Subject: Transmittal Memorandum for Engineering Handbook No. 8, Issuance 71- 10

WIND EQUIPMENT MAINTENANCE NOTE  
(For Electronics Technicians)

11, Consolidation of Supplementary Instructions for Wind Equipment.

EHB-8  
Issuance 72-5

FIGURE 17A  
F420C WIND DIRECTION TRANSMITTER MODIFIED

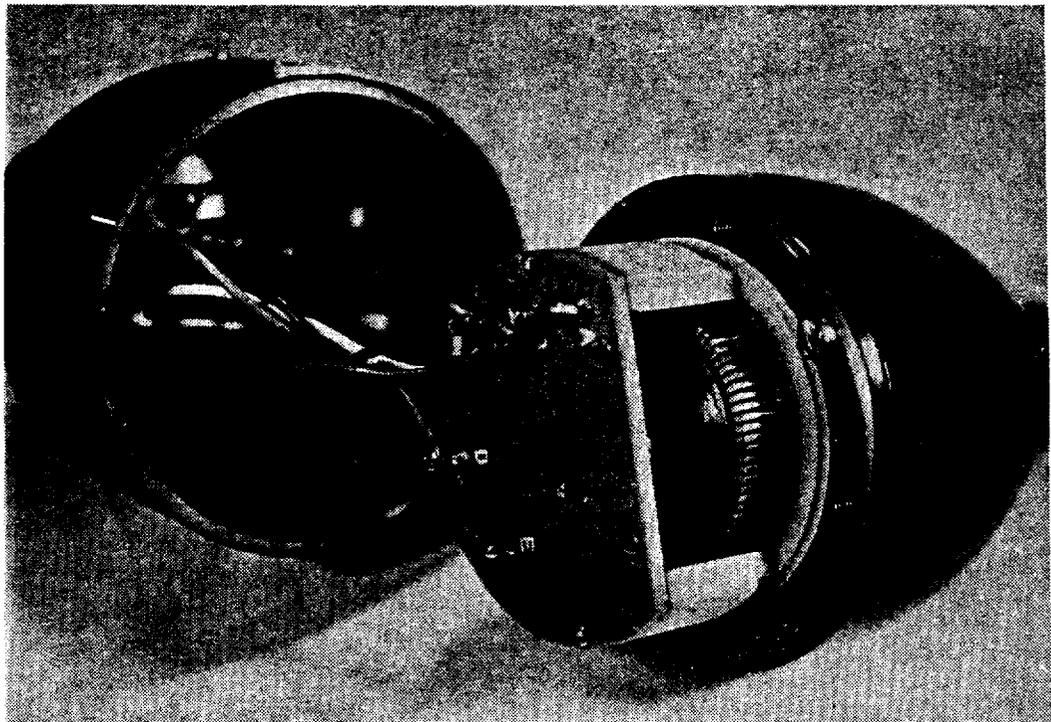
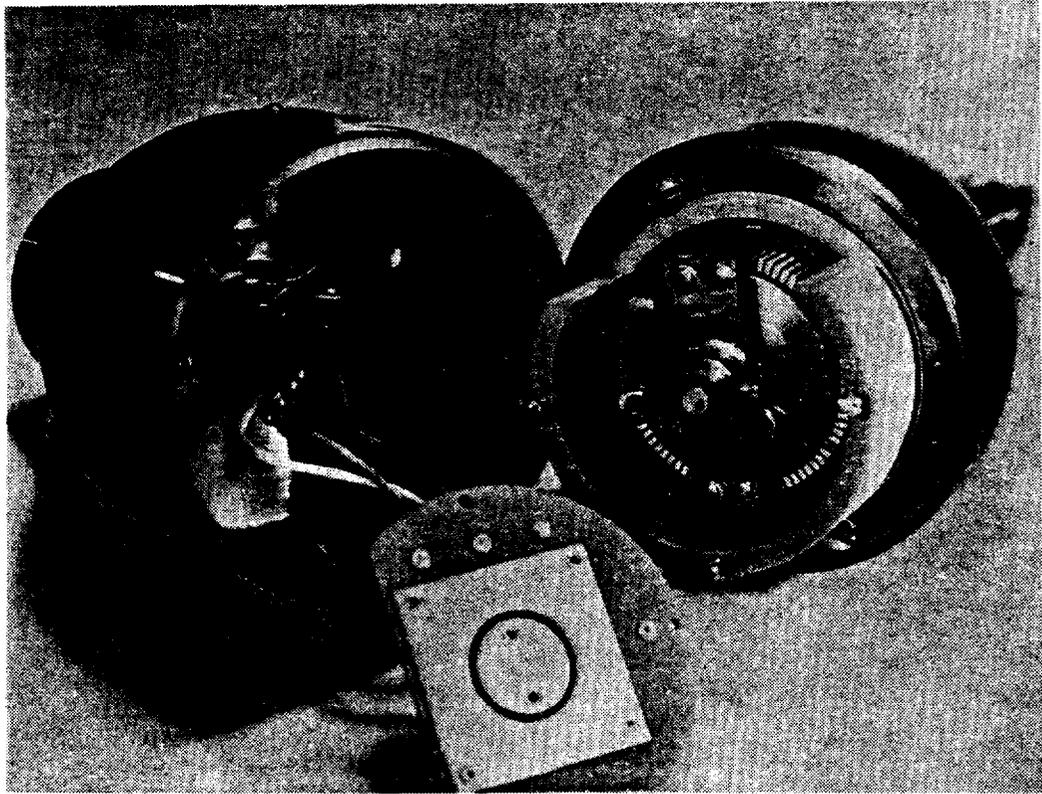
The direction transmitter incorporates a new method of ground return. The ground is no longer through the bearing, but by a brush assembly at the base of the commutator. The new direction transmitter will also have four white lines, each one inch long, inscribed at ninety-degree intervals near the top of the neck. The lines are provided for a quick check of the direction transmitter after a thunderstorm or for a routine check. The direction can be checked at north, east, south, and west by aligning the head of the wind vane with each of the white lines. The modified wind vane has a white line inscribed on the apron of the rain shield which can be aligned with the lines on the transmitter. The lines will give a greater degree of accuracy when checking the direction.

The modified wind direction transmitter is shown in Figure 17A. One copy should be removed from this maintenance note and placed in the Wind Manual between Figures 17 and 18. The other copy should remain with this maintenance note.

Figure 3-F611 Wind Retransmitter Schematic

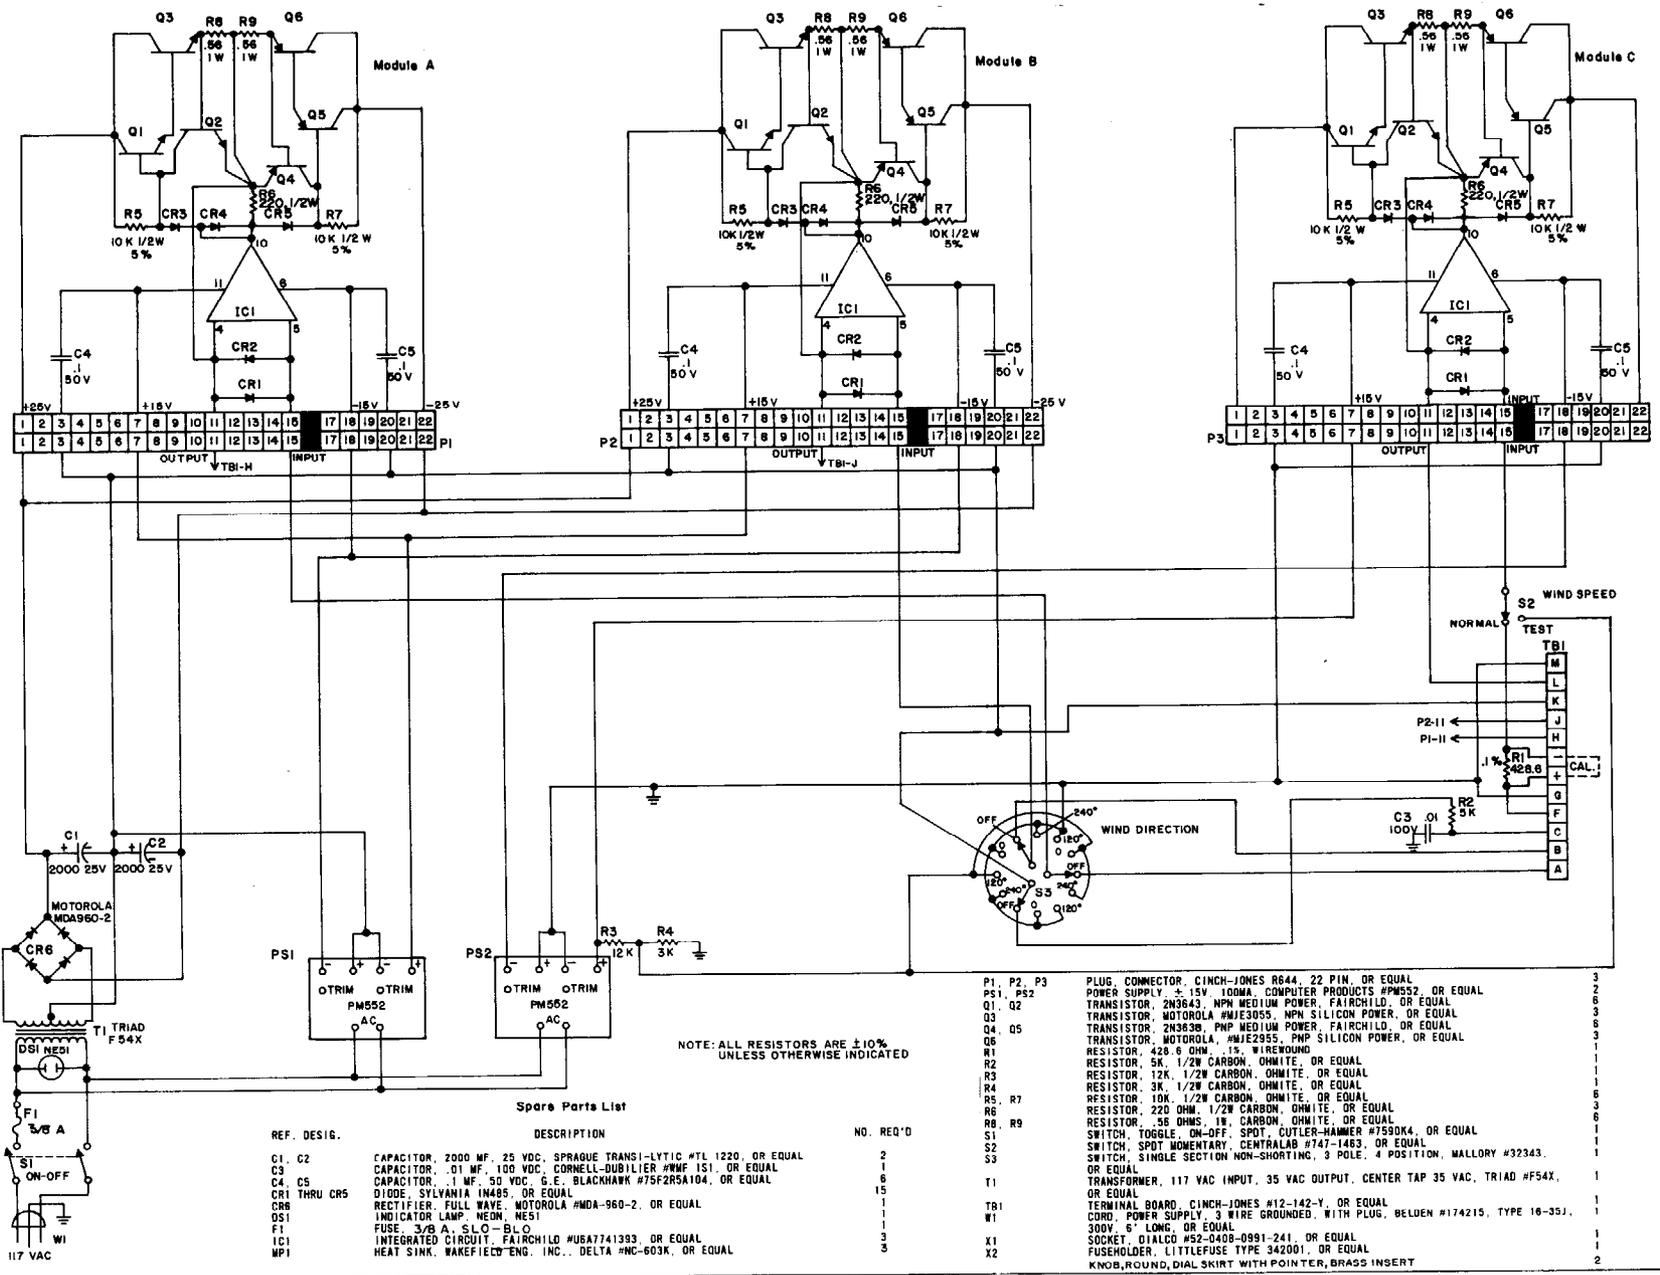
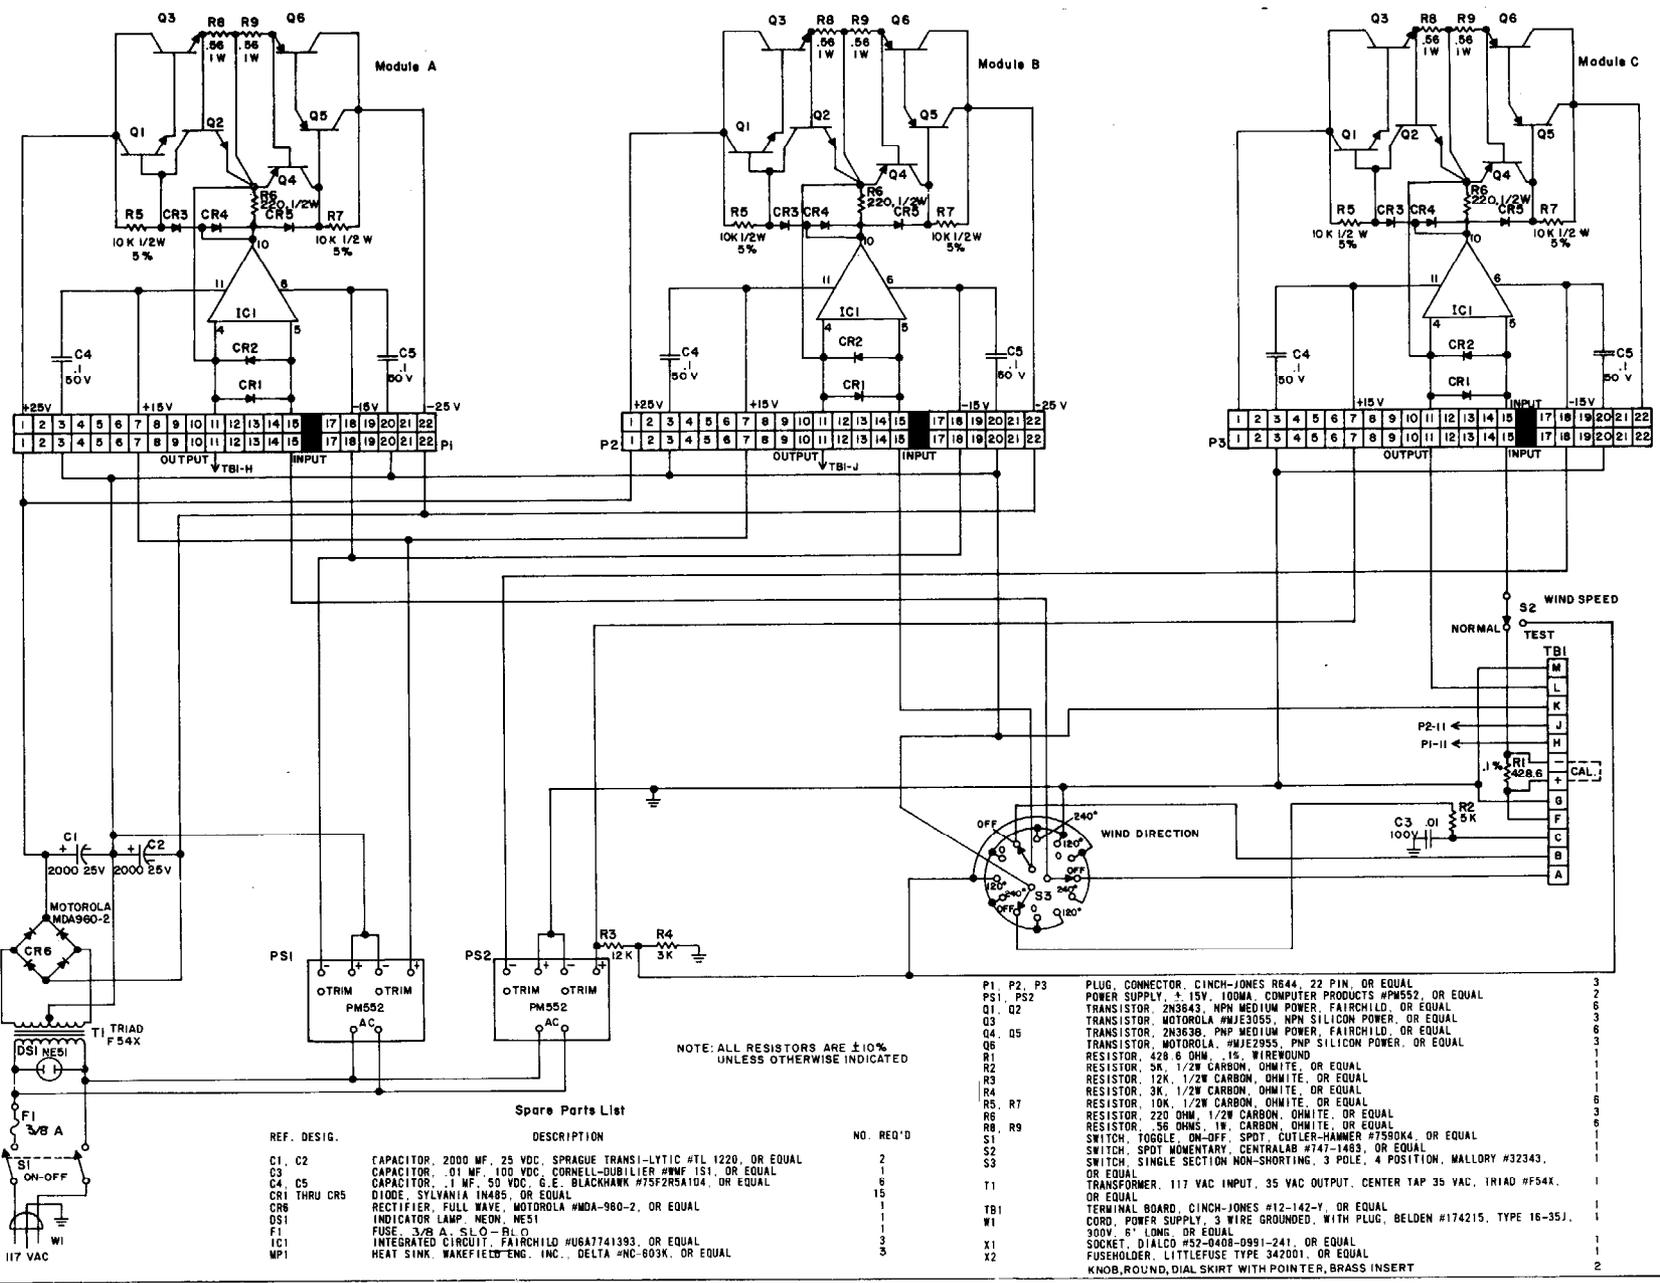
A few failures of the wind direction retransmitter modules have been reported. A component on the board would fail and cause the board to be burned beyond repair if not noticed in time. Investigation of the failures has shown that IC1 would start oscillating and cause Q3 and Q6 to draw excessive current. This would destroy R8 and R9 and sometimes other components on the board.

Under normal operation, the retransmitter draws about 300 milliamps. This unit was fused with a 2 amp fuse to protect the power transformer. However, in order to protect the modules should they become defective, this maintenance note directs ELTEC's to replace the 2 amp fuse with a 3/8 amp slo-blo. The fuses are available from the CLSC as FSN 5920-220-1317; WS Stock No. 17-F-5-10.

Two copies of revised schematic Figure 3 are attached. One copy should replace Figure 3 in the manual and the second copy is to remain with this maintenance note.

FIGURE 1- F611A WIND RETRASMITTER SCHEMATIC

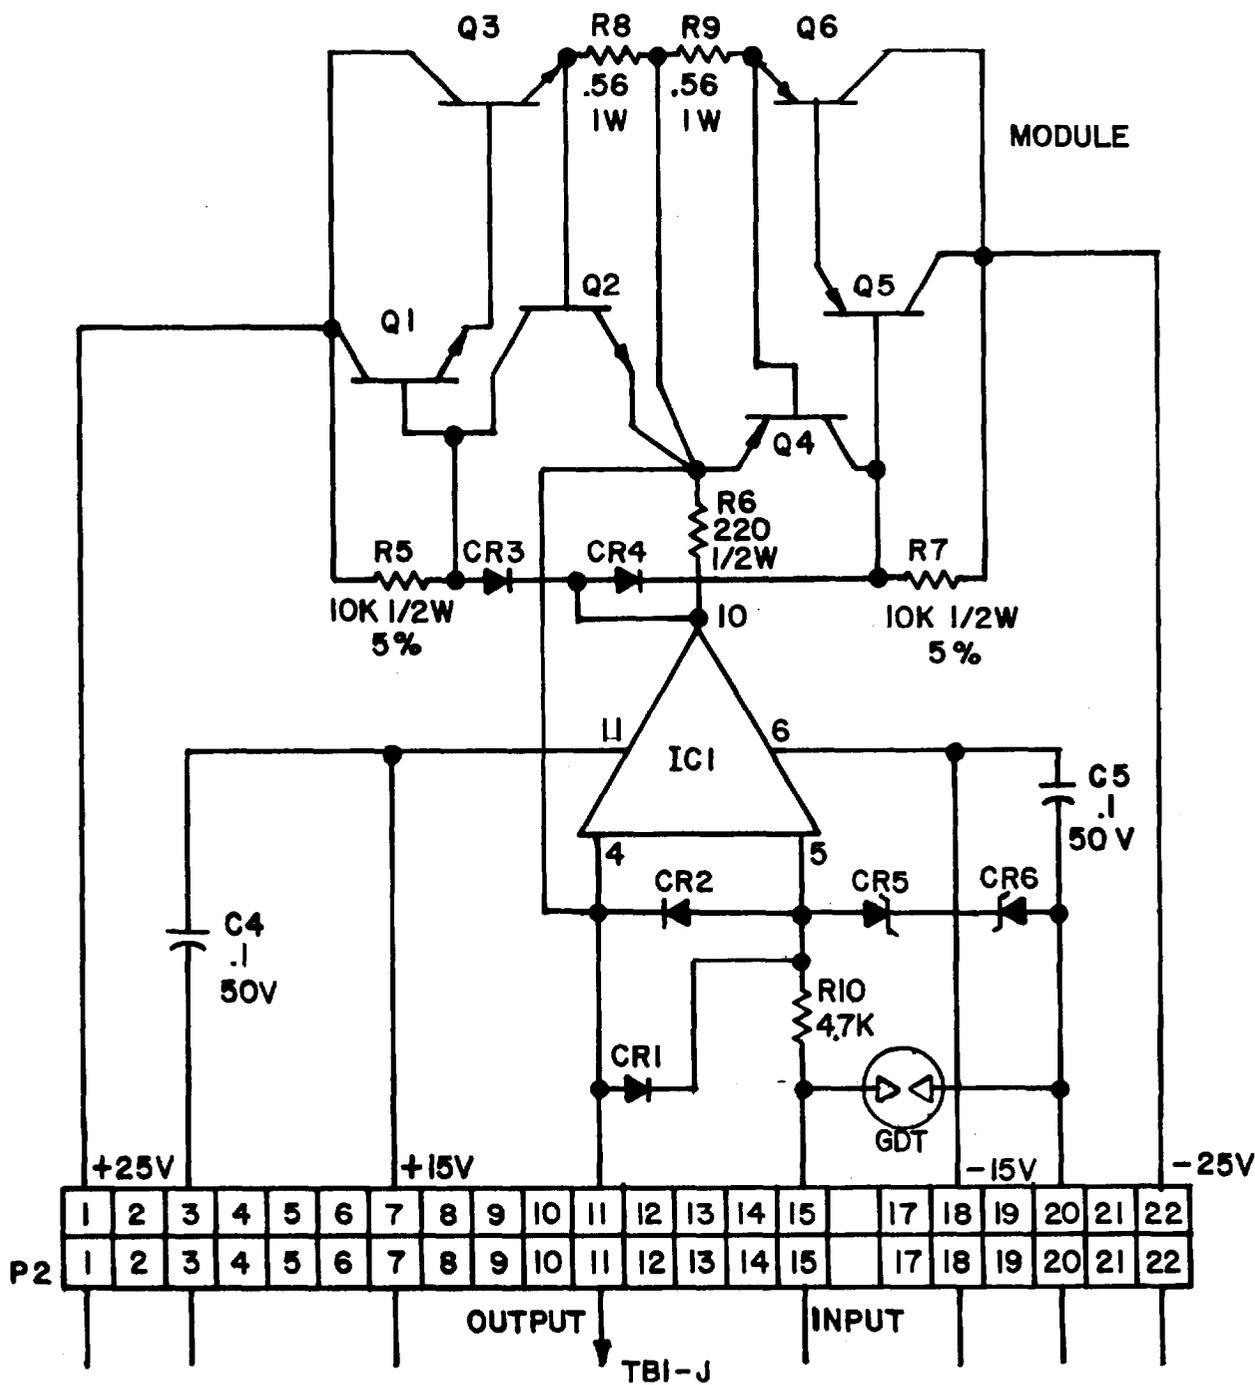
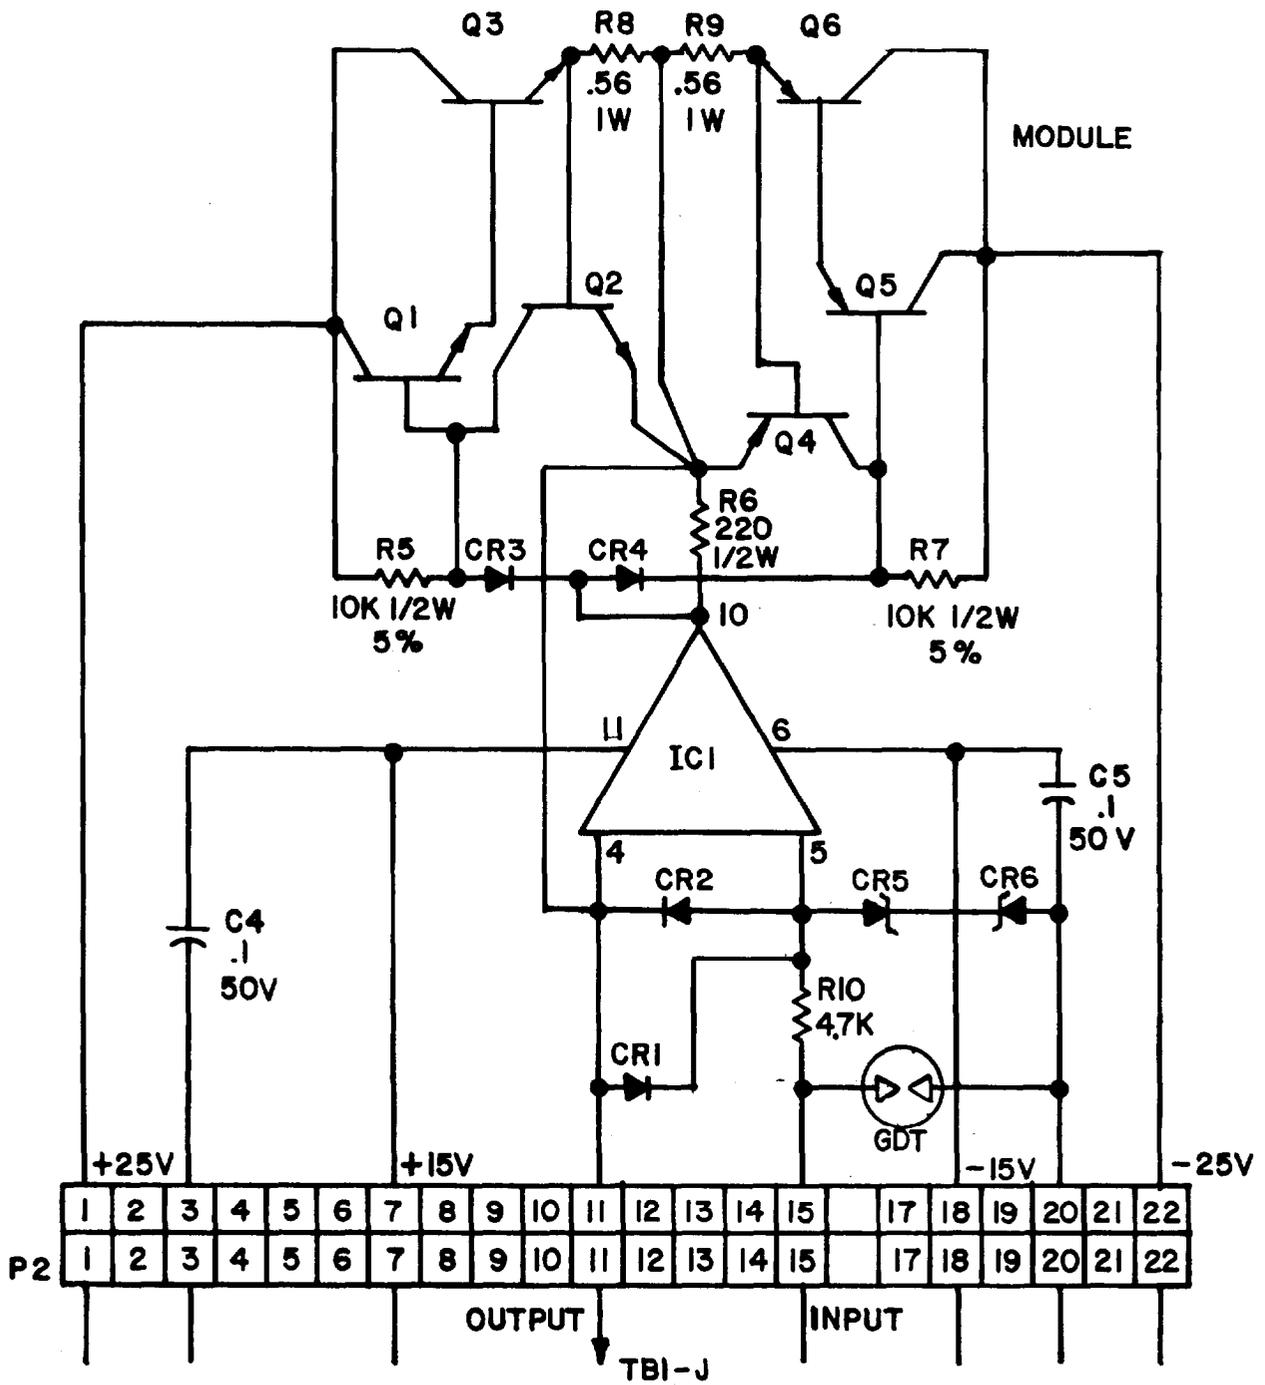
The F611A printed circuit board has been modified for lightning protection. The modified board is directly interchangeable with the board presently in use. The board should be placed in the equipment only when required by the failure of the old board. The old board should be repaired for a spare, if economically feasible. Most of the components for the board have been placed in stock at the CLSC under the following stock numbers:

In some cases it has been found that "AC" pickup and "spikes!" are being fed into the retransmitter causing the IC to start oscillating. The oscillating will cause Q3 and Q6 to become defective. Experience has shown that a .01 to a .05 ufd capacitor placed from each input to the common terminal will sometimes correct the situation.

Two copies each of the printed circuit board schematic, spare parts list, and component layout are attached. One copy each should be removed from the maintenance note and placed in the F611 Solid State Wind Retransmitter Manual, EHB8-213. The other copy should remain with this maintenance note.
